Access Compliance Report

(Curb Ramps)

Intersection ID: 23662	Main Street: CARMEL_RD	Cross Street: RED_OAK_LN	Location:	E
ADA ID: B9F0837CB088	Ramp Type: MedianPerp	Initial Pass/Fail: Fail	Overall Compliance: No	Severity Score: 25
Codes/Mitigation Info/Possible Solution		Field Measurements/Component Compliance

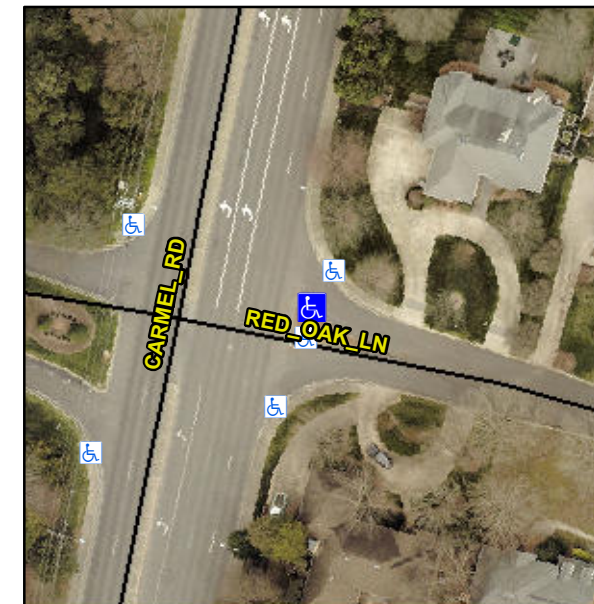
R304.2.2, R304.5.3

Compliance	Description	Data	Compliance	Description	Data
N/A	Ramp Length (in)	57.0	No	Ramp Slope (%)	8.7
Yes	Ramp Width (in)	58.0	No	Ramp XSlope (%)	5.7
N/A	Flare Type LT	N/A	N/A	Flare Type RT	N/A
N/A	Flare Slope LT (%)	N/A	N/A	Flare Slope RT (%)	N/A
N/A	Flare Traversable LT?	N/A	N/A	Flare Traversable RT?	N/A
N/A	Landing Length (in)	N/A	N/A	DWS Provided?	N/A
N/A	Landing Width (in)	N/A	N/A	DWS Contrast?	N/A
N/A	Landing Slope (%)	N/A	N/A	DWS Length (in)	N/A
N/A	Landing X Slope (%)	N/A	N/A	DWS Full Width?	N/A
N/A	Landing Curb? (Y/N)	N/A	N/A	DWS Offset (in)	N/A
N/A	Shared Landing?	N/A			
N/A	Gutter Ponding?	N/A	N/A	Gutter Slope (%)	N/A
N/A	Gutter Lip Ht (in)	N/A	N/A	Gutter X Slope (%)	N/A
N/A	Painted X Walk1?	No	N/A	Painted X Walk2?	N/A
	X Walk 1 Direction	To N		X Walk 2 Direction	N/A
N/A	X Walk 1 Width (in)	N/A	N/A	X Walk 2 Width (in)	N/A
	X Walk 1 Slope (%)	0.6		X Walk 2 Slope (%)	N/A
	X Walk 1 X Slope (%)	5.1		X Walk 2 X Slope (%)	N/A

Remove & Replace Entire Ramp.
